BID ADDENDUM NO. 2
ITB/004/16/KL
CITY OF WINTER SPRINGS
WTP NO. 1 WATER QUALITY IMPROVEMENTS

March 7, 2016

This addendum sets forth changes and/or information as referenced and is hereby made a part of, and should be attached to, the subject Contract Documents.

WTP NO. 1 EXISTING HSP BLDG. & GENERATOR BUILDING ELECTRICAL DEMOLITION PLAN

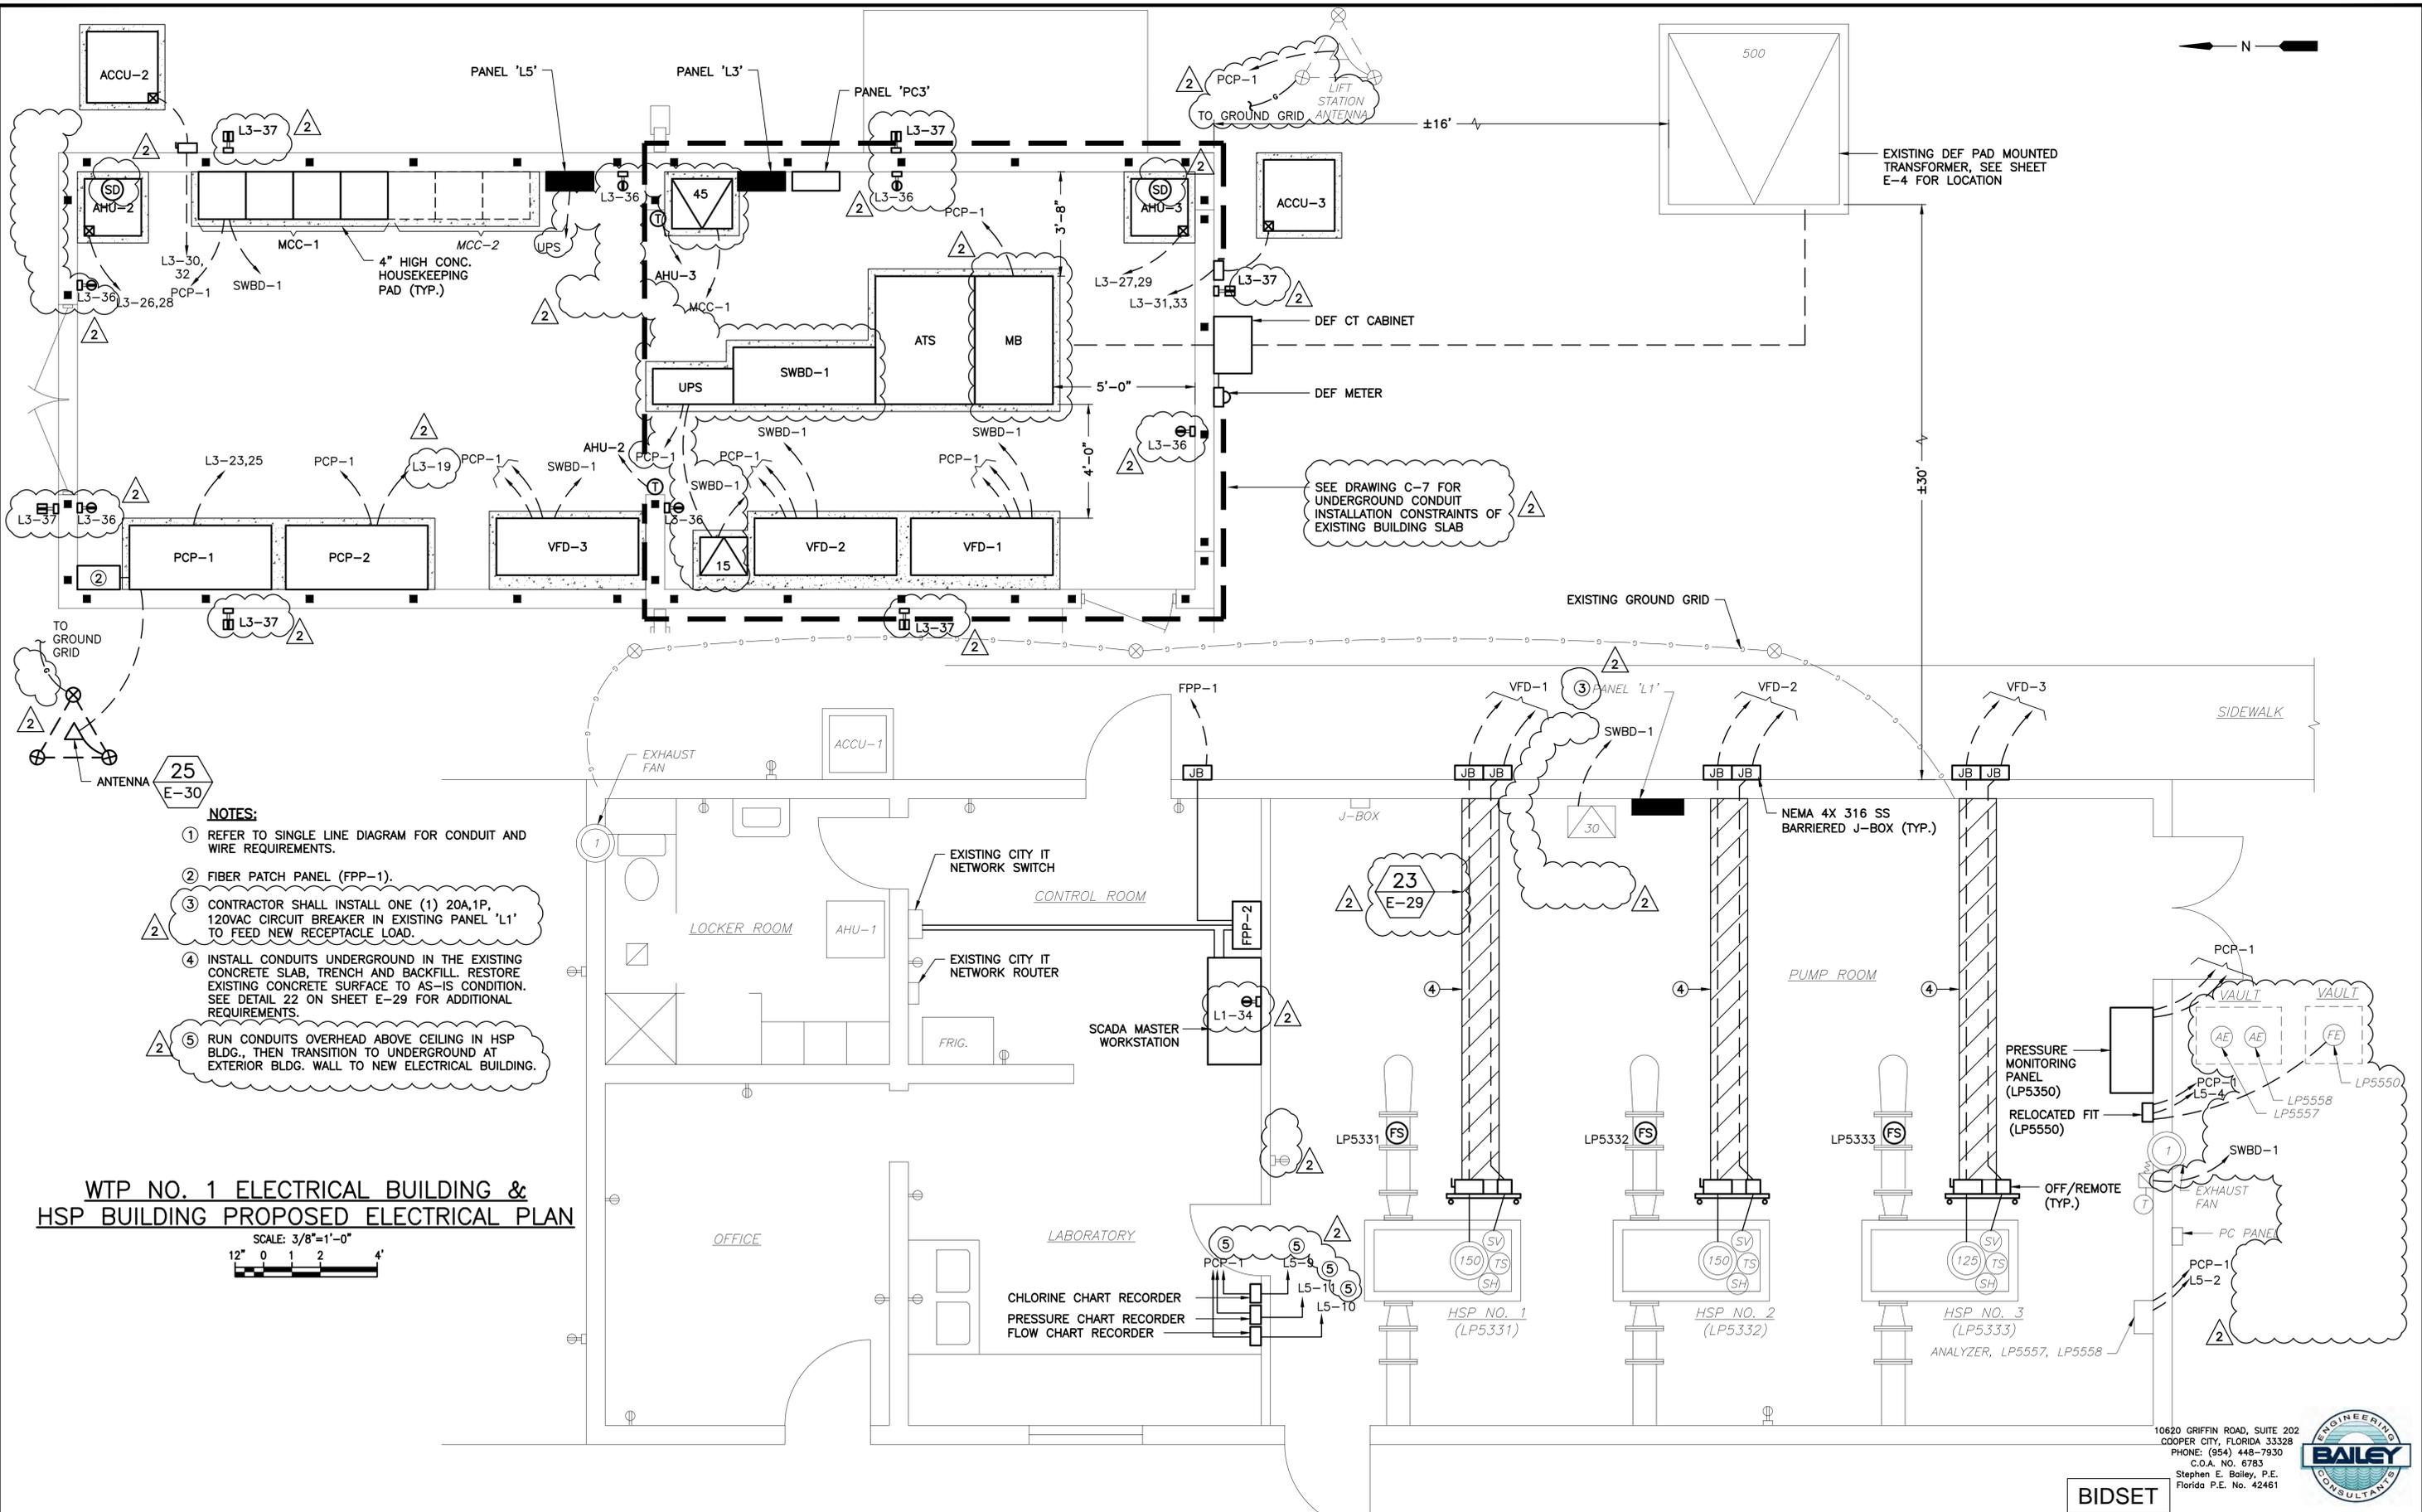
Comment No. 3-8: E-12 & E-13 call for removal of the existing generator and construction of the new electrical room. Will a temporary generator be required onsite for this work? If so, who will be responsible for providing the temporary generator and fuel? We recommend this be provided by the City or an Allowance be provided because the generator will only be used in unknown outages.

Response No. 3-8: See attached response provided by Electrical Engineer.

BIDSET
 ION EXCHANGE OVERALL
 ELECTRICAL PLAN

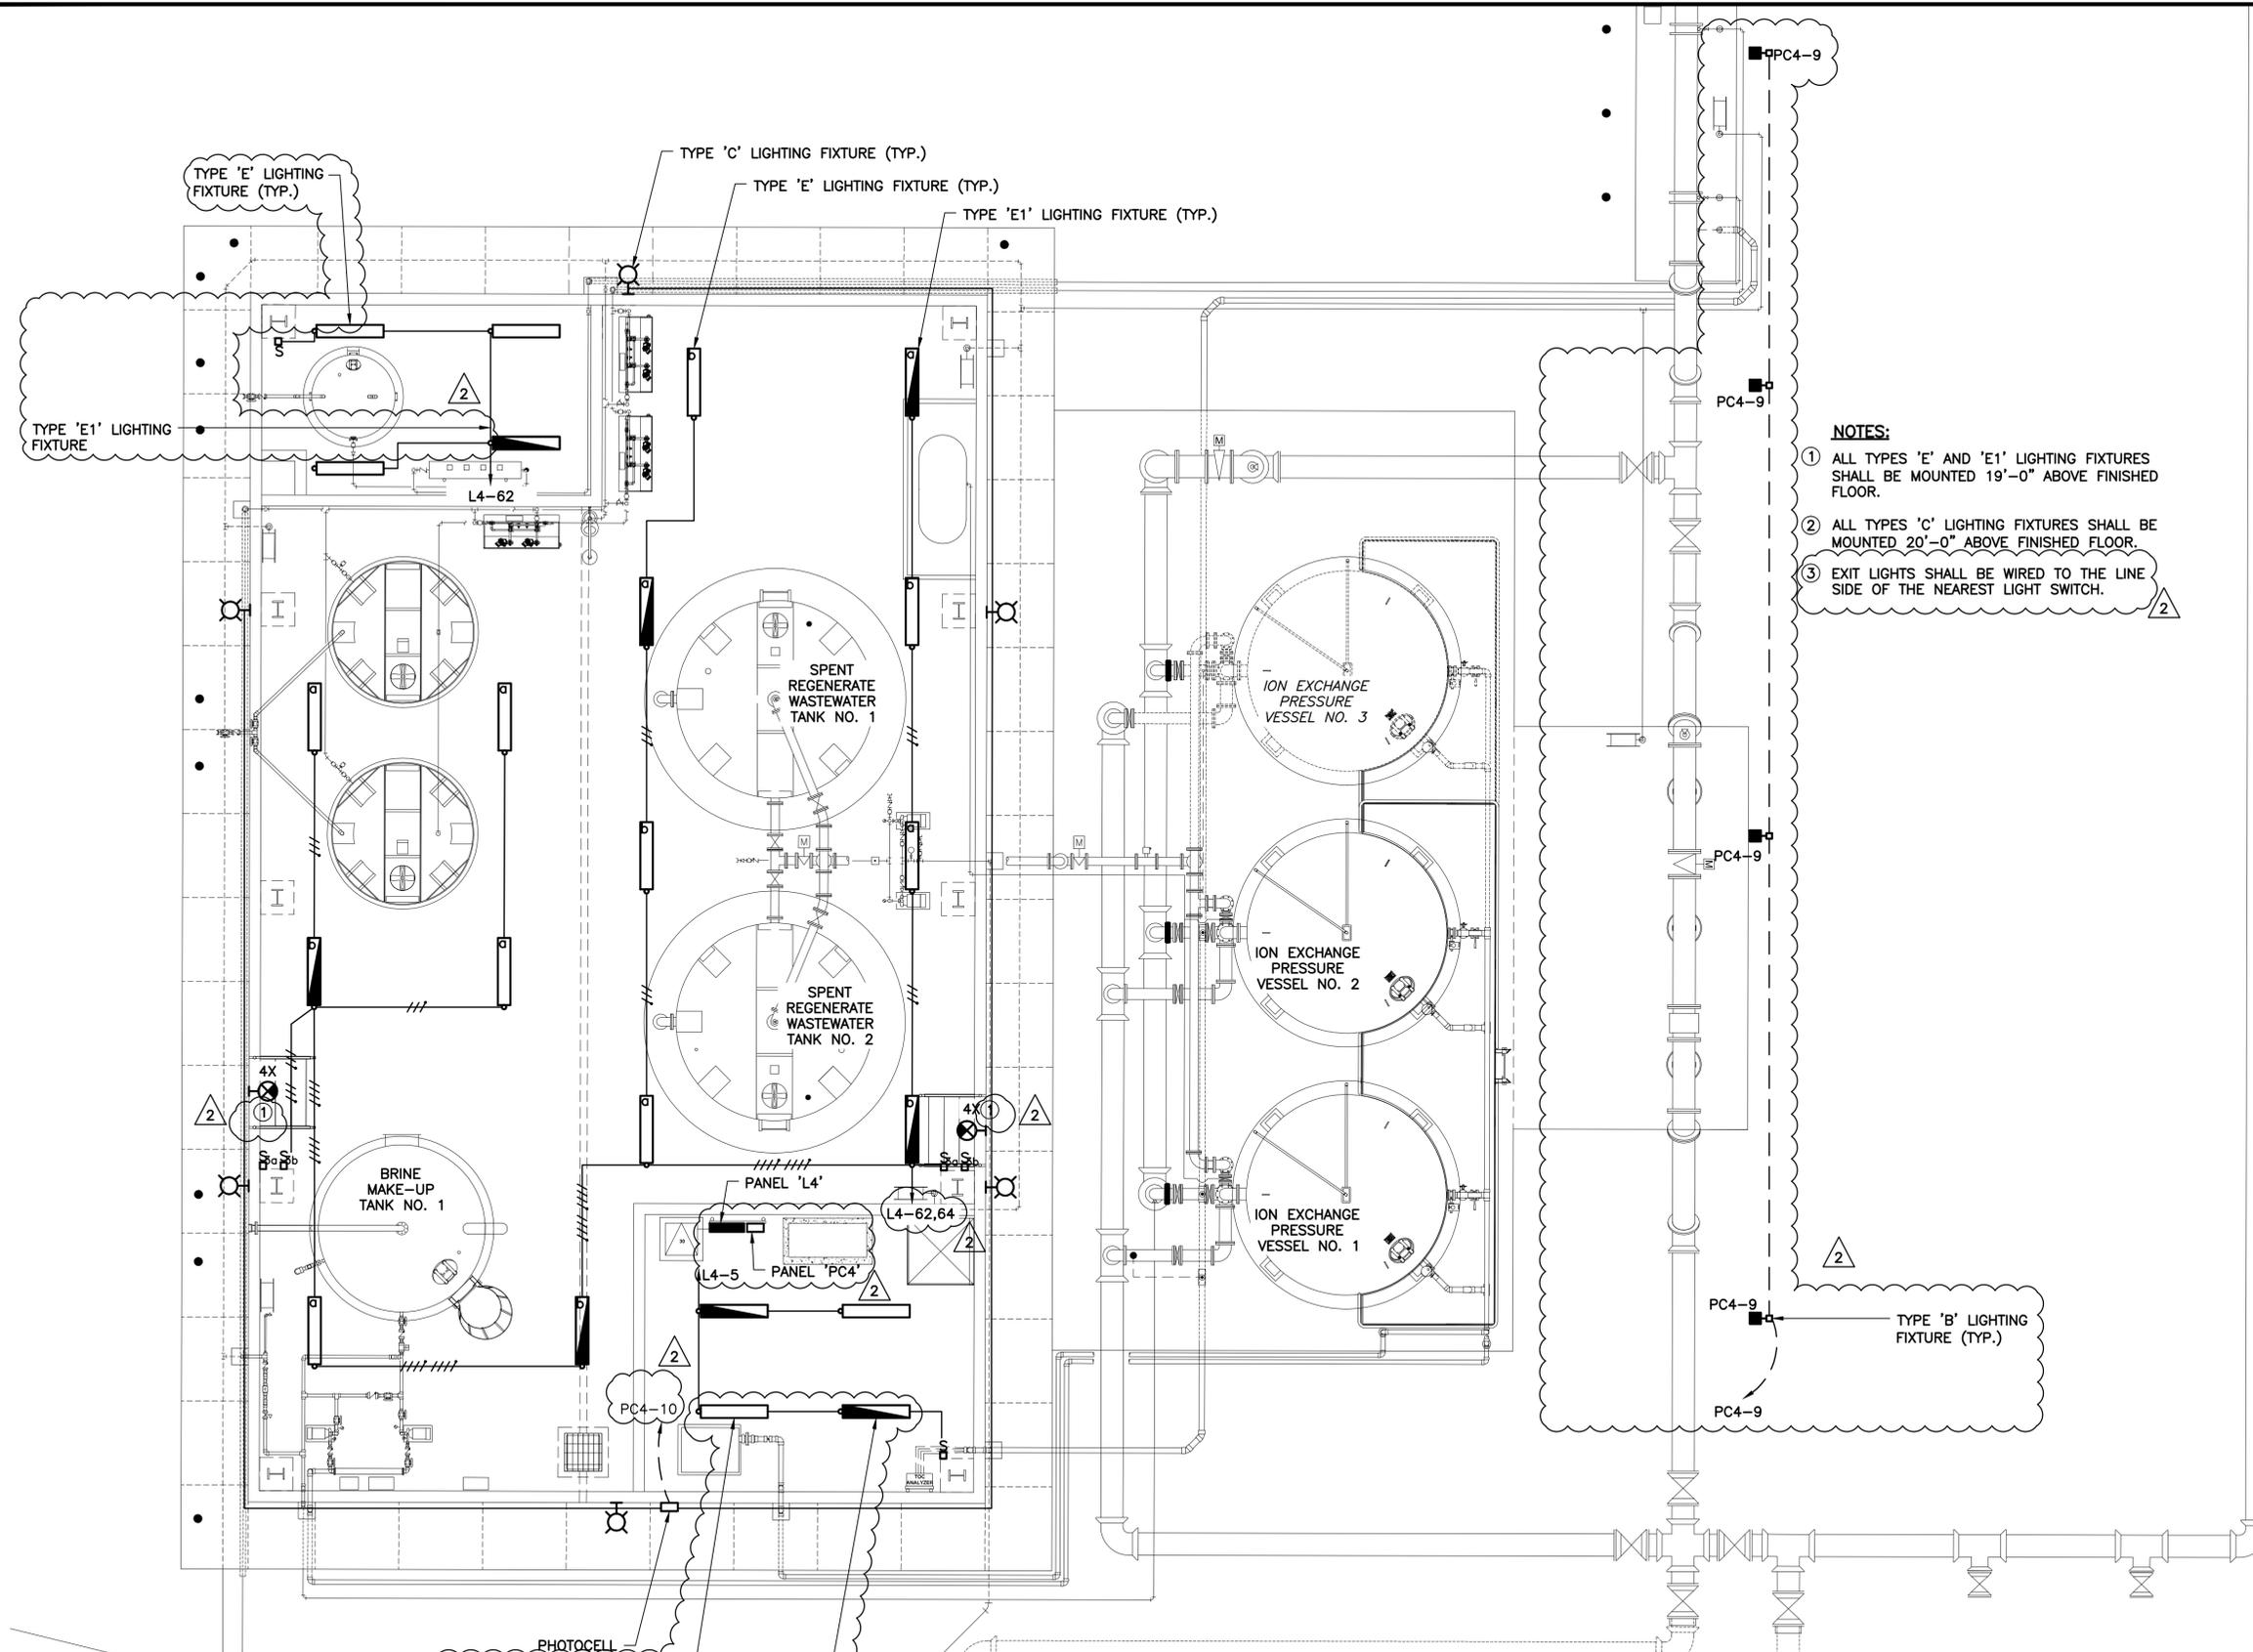
Comment No. 2: Looking to the drawings, it is also confusing. Sheet M-1 has PCP-2 located in the same location where the RCP-2A is located in Sheet E-17 (detail).

Response No. 2: RCP-2A is located as shown on sheet E-17.

ION EXCHANGE UNIT NO. 1
ALL INSTRUMENTS FURNISHED UNDER SECTION 11700

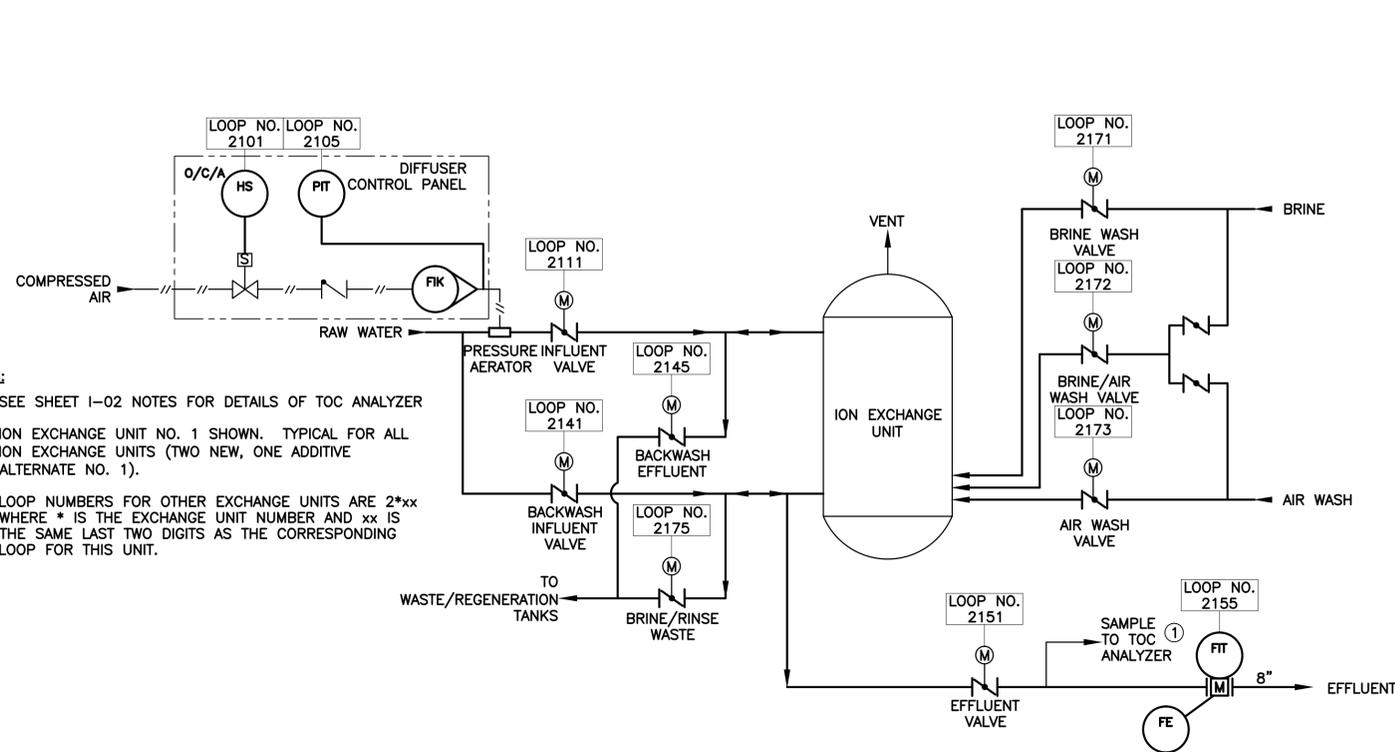
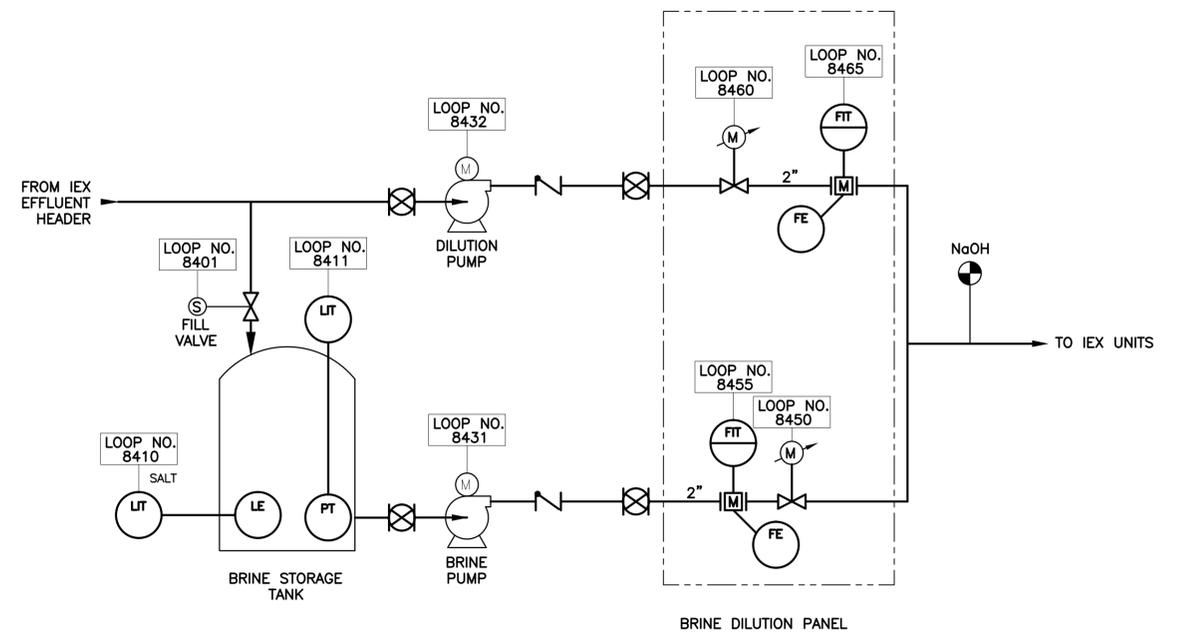
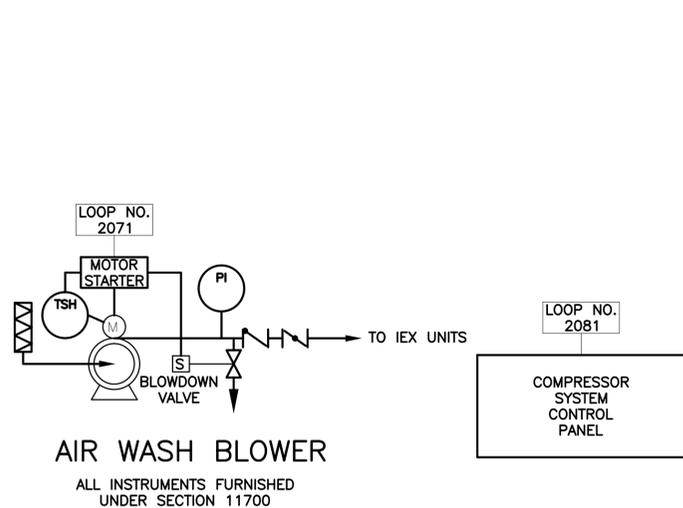
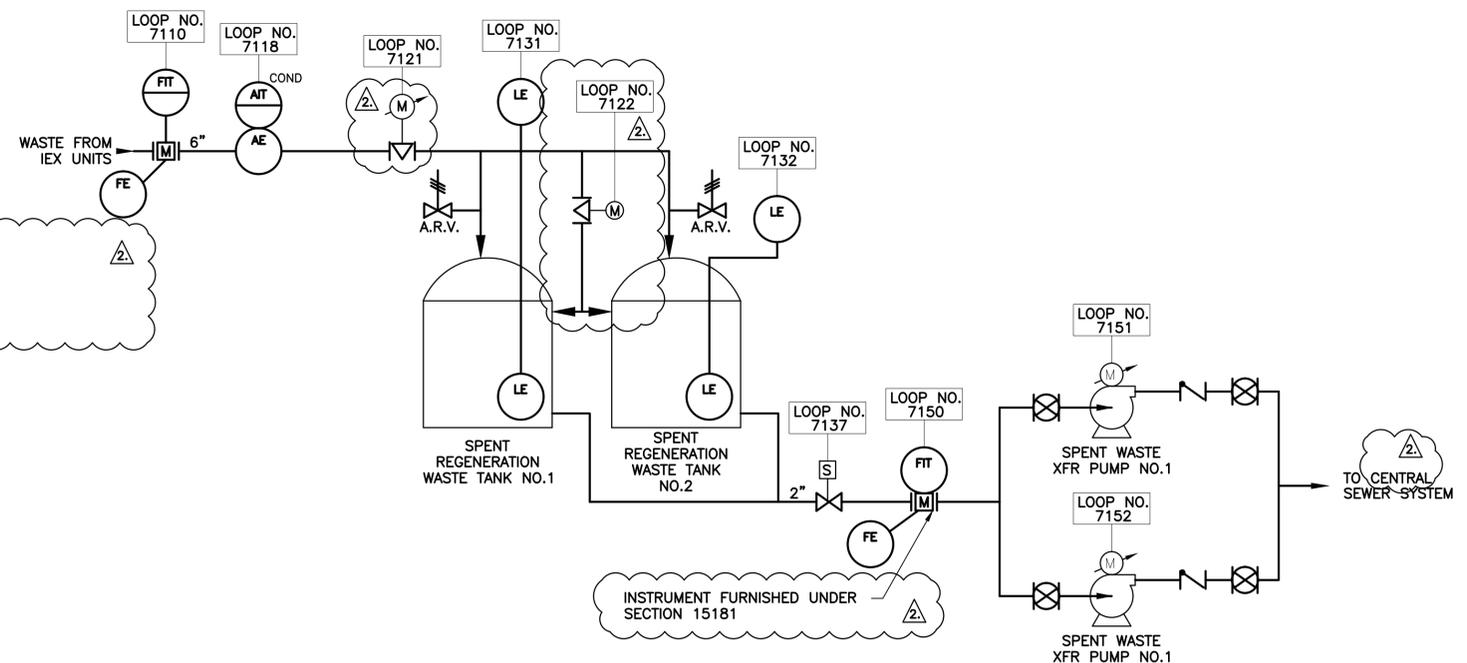
Comment No. 2: There appears to be some instruments on drawing I-3 & I-4 which are not referenced in specifications section 13310 and lay outside of the dashed lines indicating equipment furnished under section 11700. Please advise regarding the following instruments not included in 13310.

Response No. 2: Loop 2155 magmeter. As noted on sheet I-3, this instrument is furnished under Specification Section 11700.

Loop 8411 submersible level sensor. As noted on sheet I-3, this instrument is furnished under Specification Section 11700.
